**Halton District School Board
RFT 25-061 School Renovation Project - Paul A Fisher PS**

Addendum No. 3

PROJECT NO. 24131
HOSSACK ARCHITECTURE

ADDENDUM NO. 3

DRAWING SP2

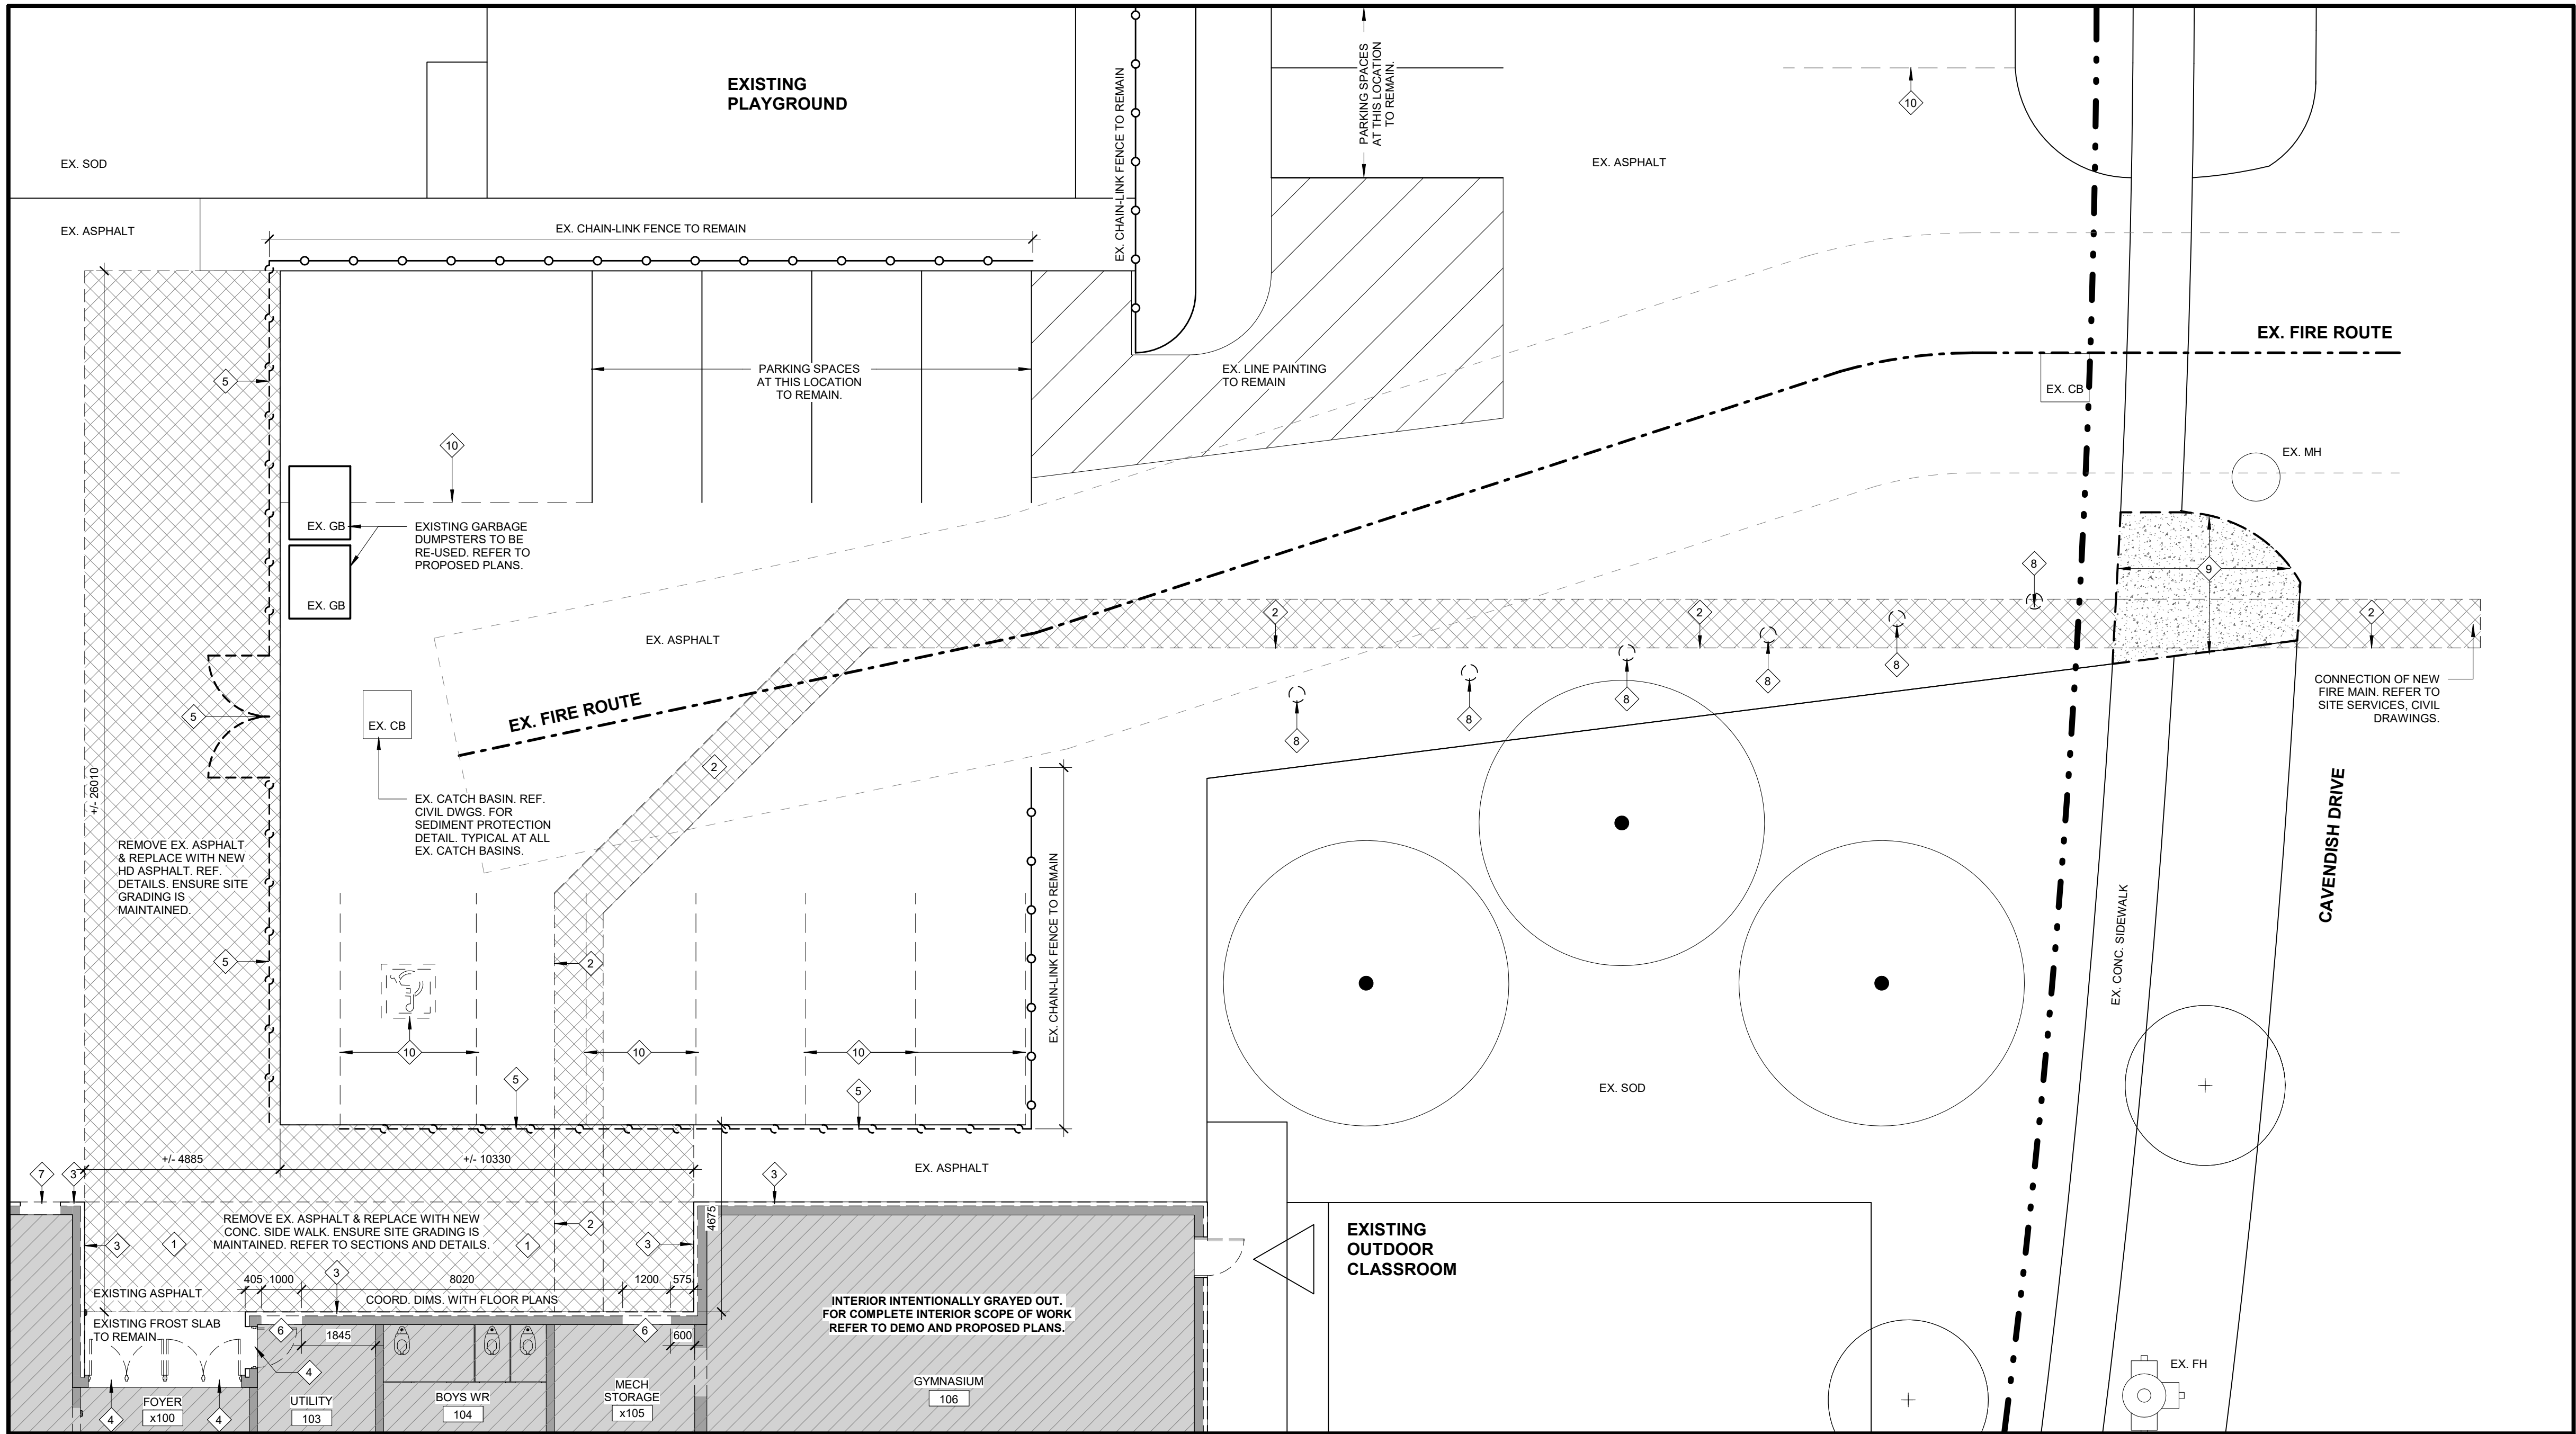
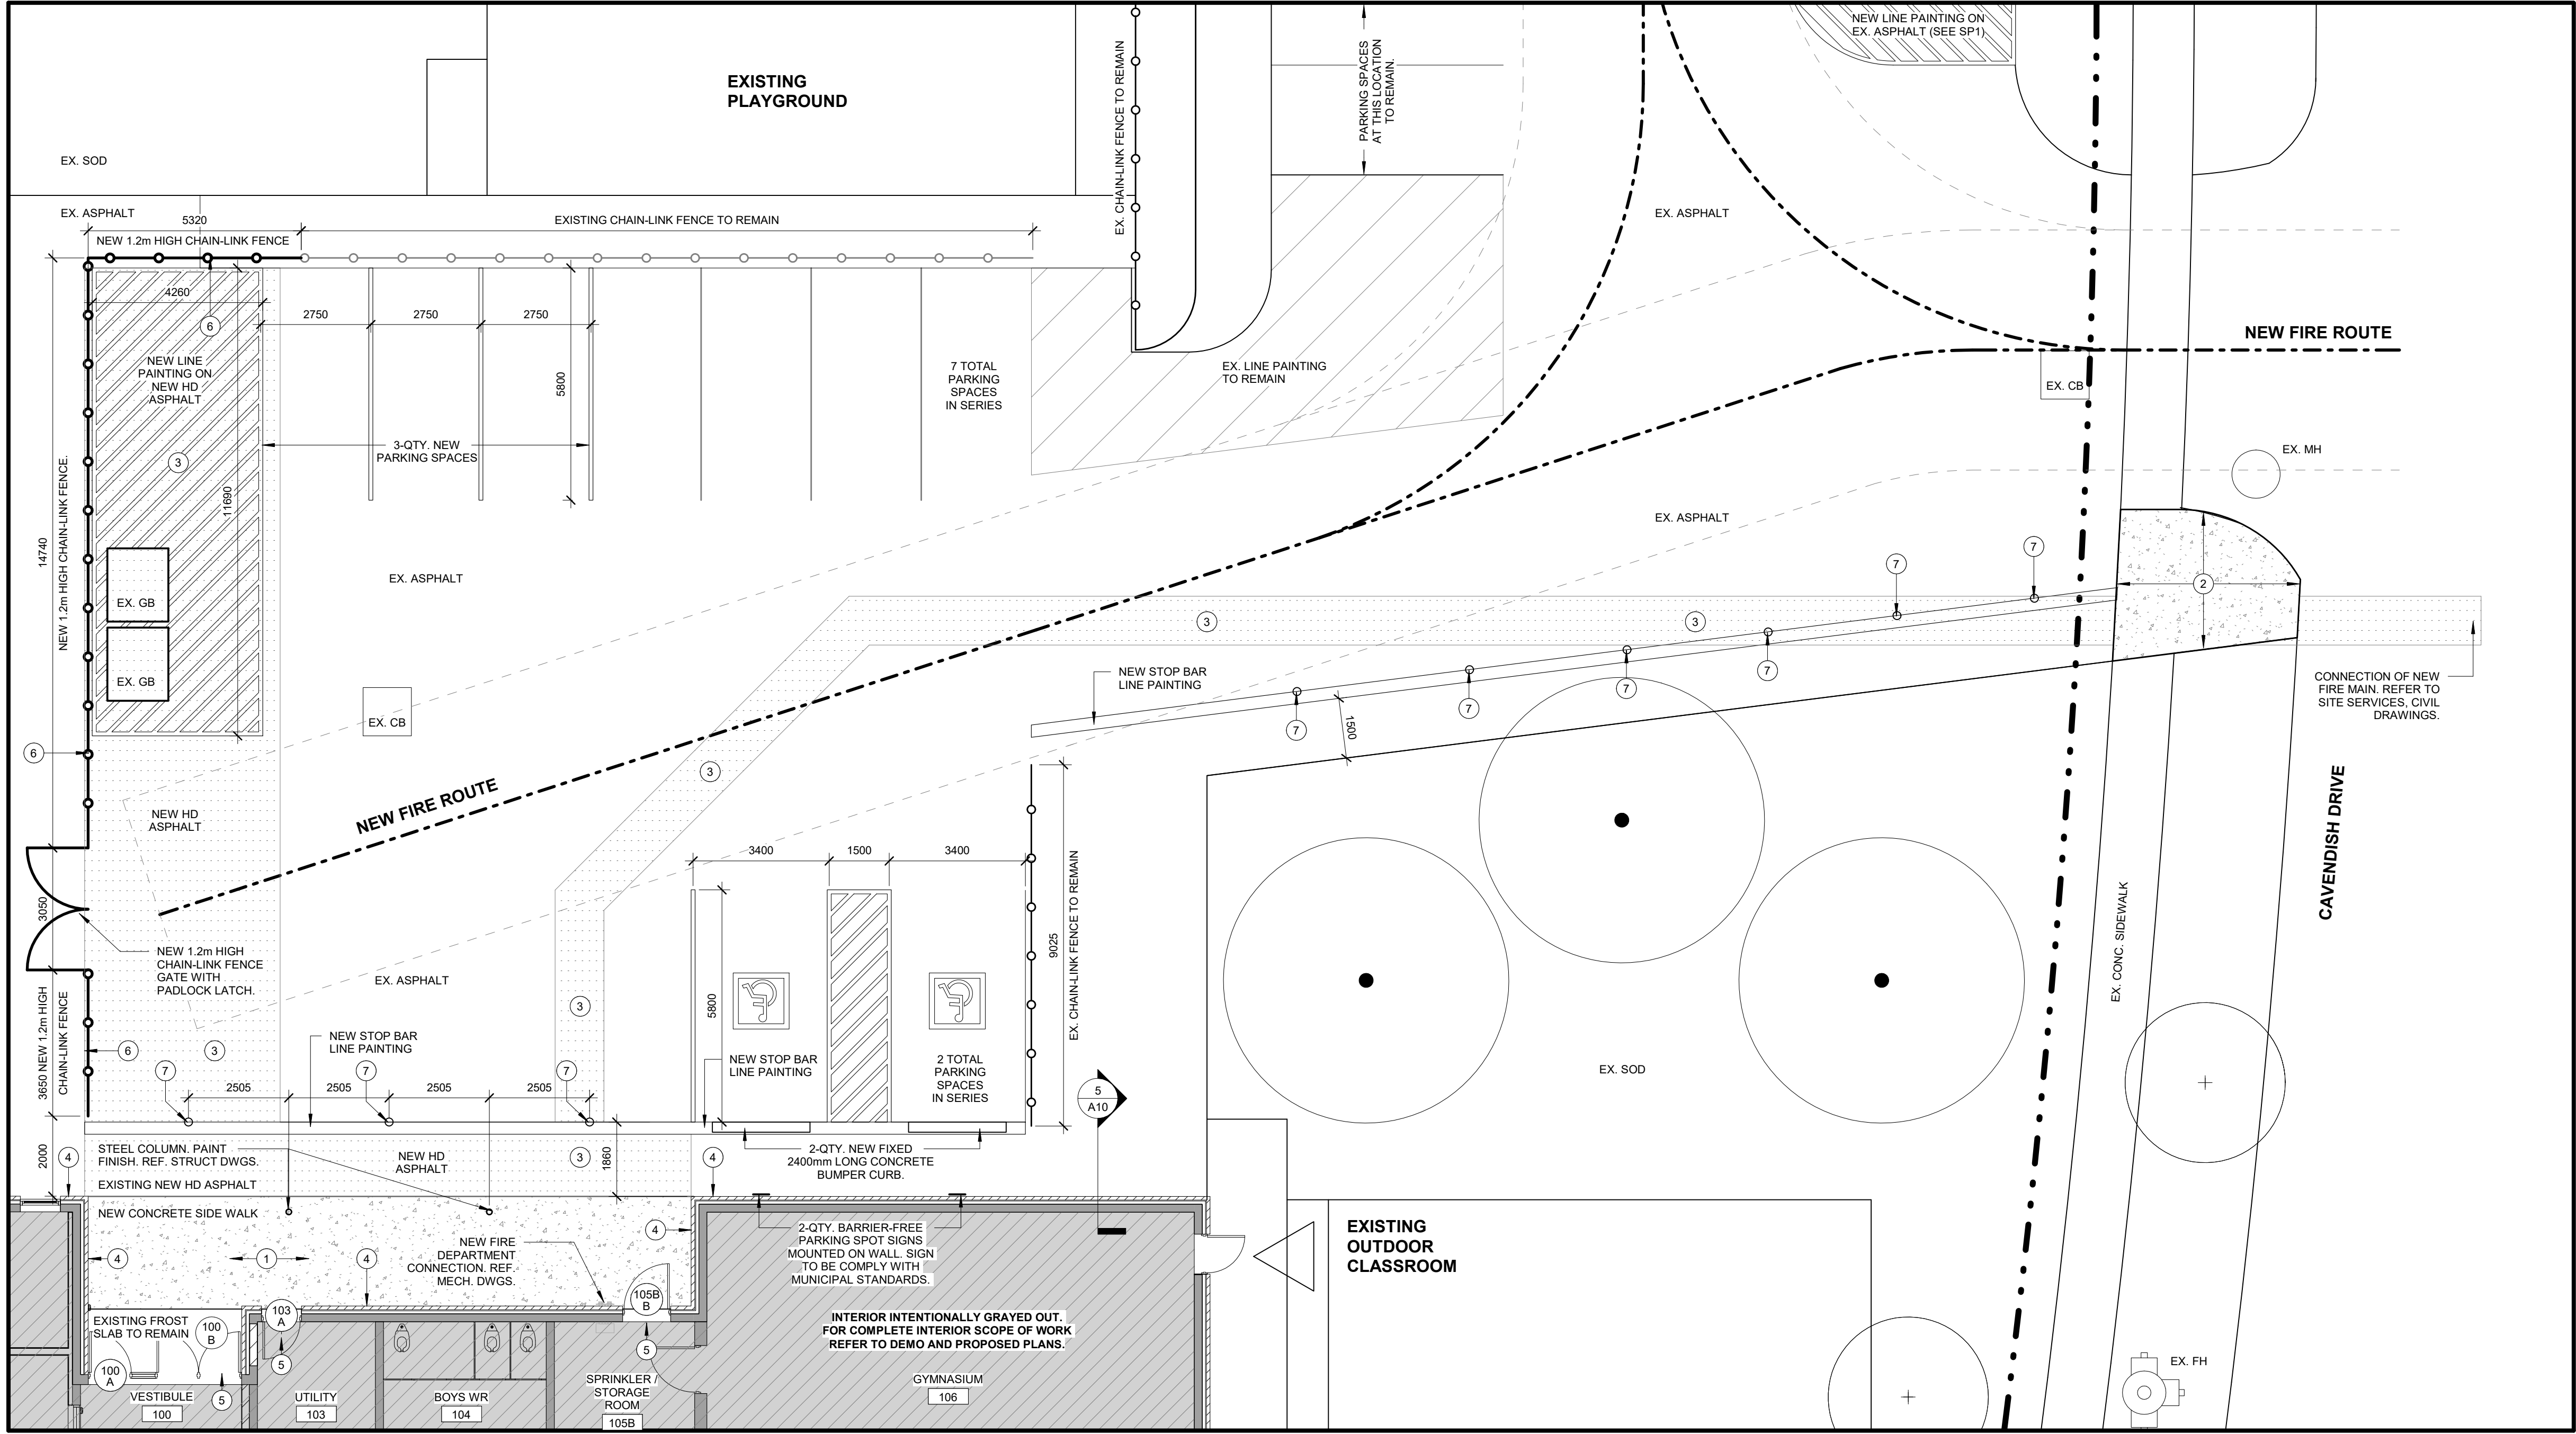
- .1 ADD this new drawing to show revisions to Fire Route and Parking Area required to accommodate Building Permit Review Comments.

DRAWING SK1.01

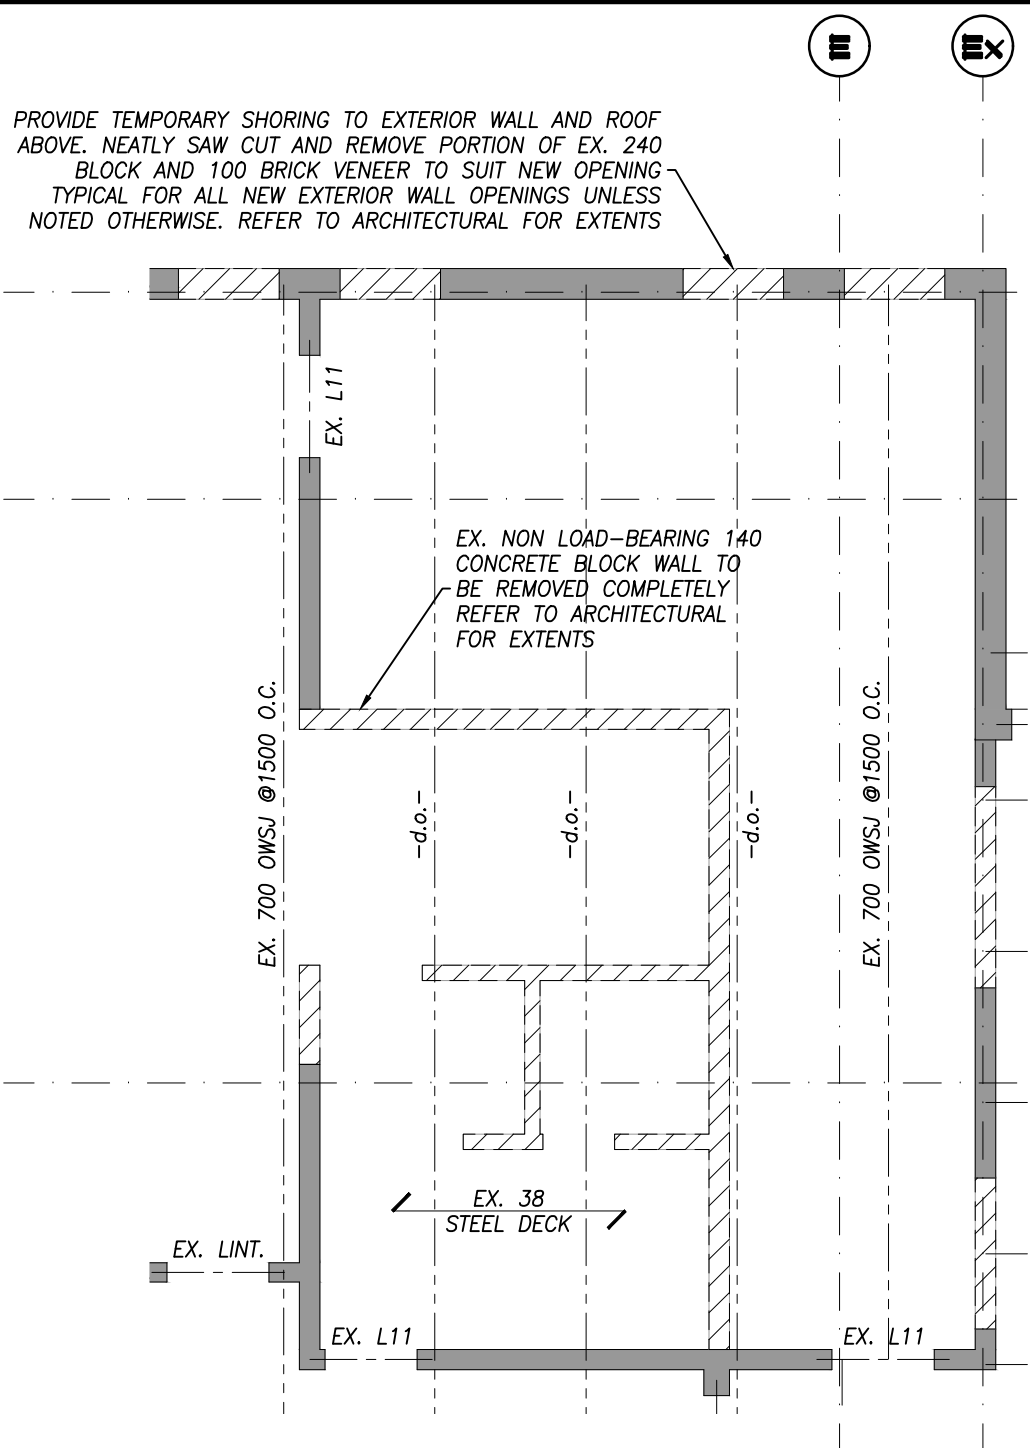
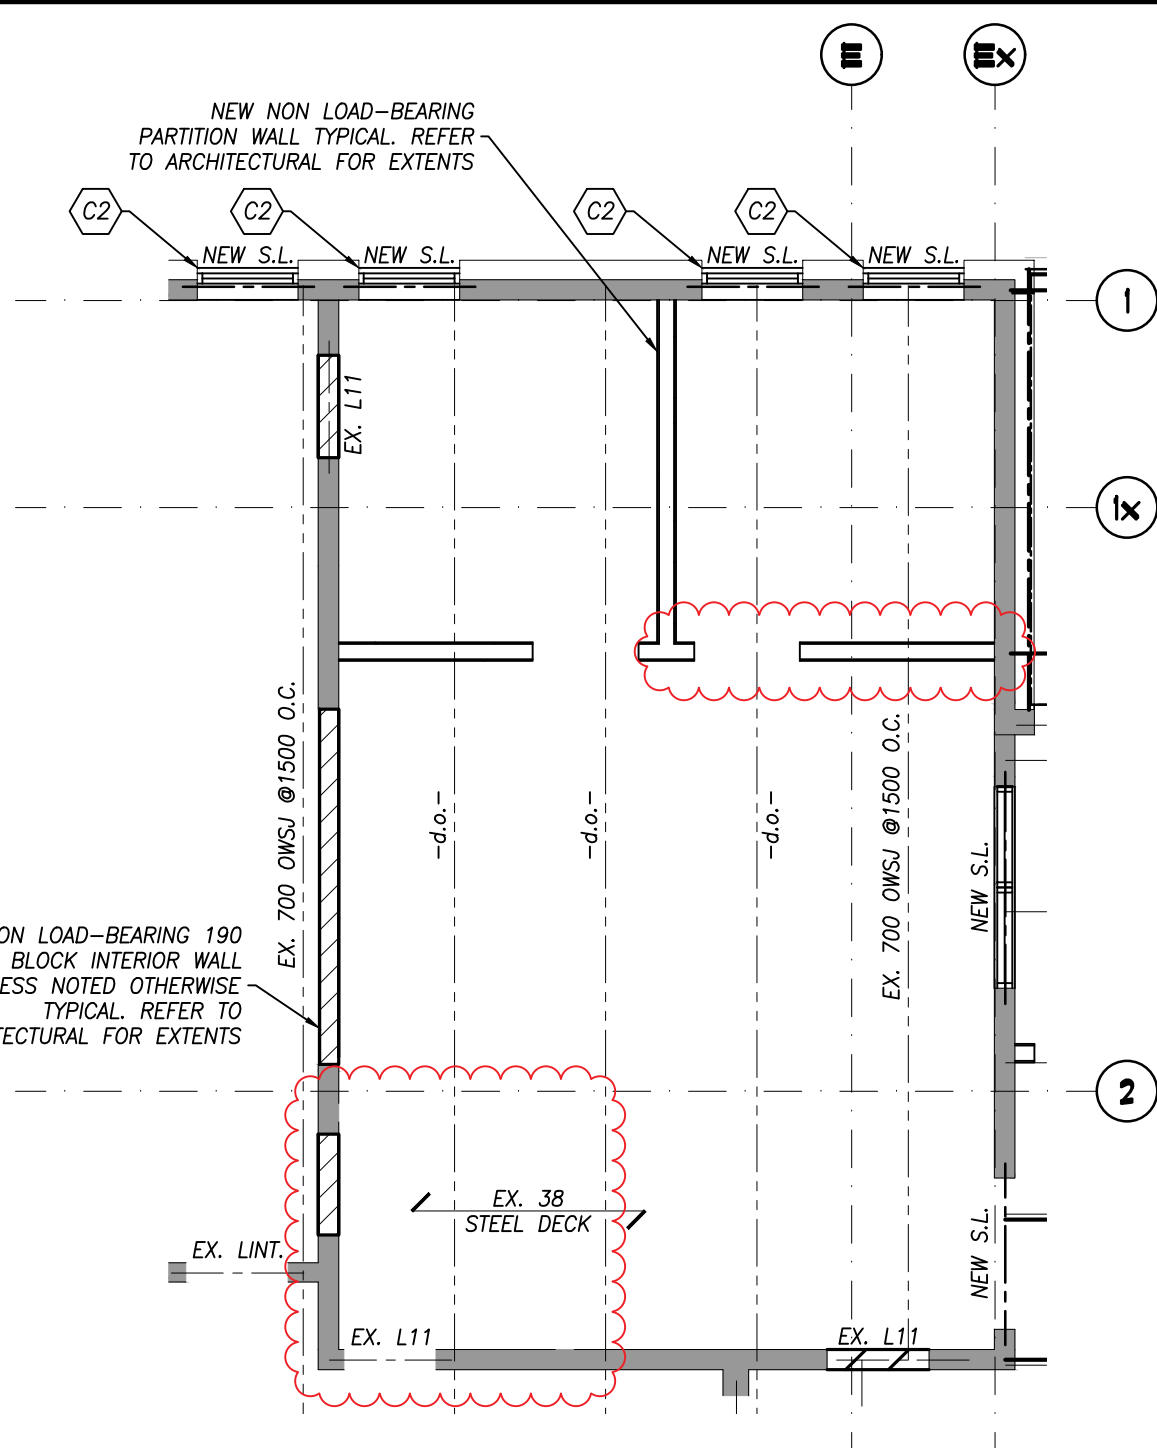
- A. Refer to [Drawing SK1.01: General Office Revisions]:
 - Revised architectural layout.
 - Revised the general note regarding the steel stud partition walls.
- B. Refer to [Drawing SK1.02: Staff Lounge Revisions]:
 - Revised architectural layout.
 - Added a new steel lintel for the new door opening in the existing masonry wall.
 - Revised the general note regarding the steel stud partition walls.

- C2 EXISTING EXTERIOR BRICK TO BE REMOVED SHORE UP AND BRACE EXISTING 240 CONCRETE BLOCK WALL. NEATLY SAW CUT AND REMOVE PORTION OF EXISTING CONCRETE BLOCK WALL TO SUIT NEW OPENING. PROVIDE STEEL LINTEL TO SUPPORT EXISTING BLOCK AND NEW BRICK VENEER SIZED AS PER STEEL LINTEL DETAIL ON DRAWING S2.0. REFER TO ARCHITECTURAL FOR EXTENTS.
